Technical Bulletin

Date	Bulletin #	Model
[11/12/2024]	124	Affects All Doors Using Opus Control
Subject Changes to Opus control for Revision F32

Encoder Inspection

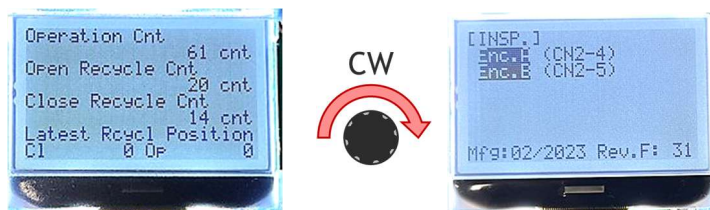
A screen has been added to check the functionality of the motor’s encoder.

Go to the settings menu, then to “history data”. From that screen, rotate clockwise to the “insp.” screen.

At this display, you can move the door very slowly by hand. As the door moves, “Enc.A” and “Enc.B” will change between being highlighted and not highlighted. Note that the VS-150 operator will also have an “Enc.C”
